ADDENDUM NUMBER: TWO (2)

TITLE: 1412230678 (IFB) BC-05 Head Chute and Diverter Fabrication

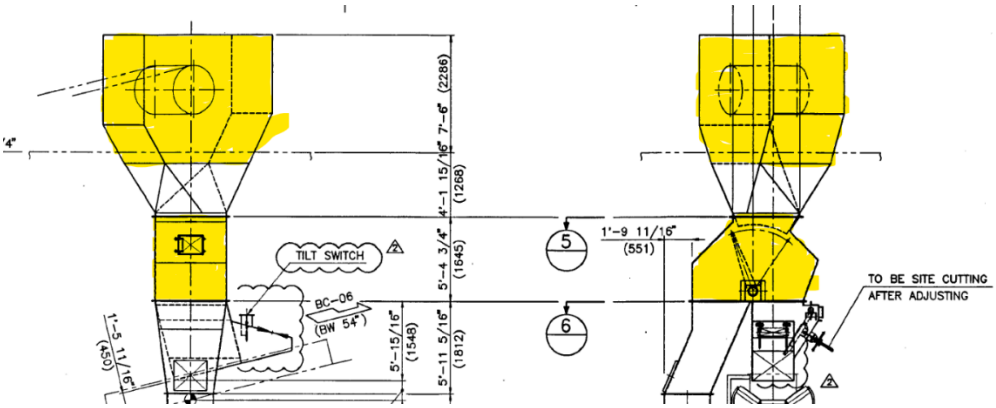
2. **Question:** Please clarify what the diverter and chute are in the drawings.

Answer: Please refer to the highlighted sections in the photo below.
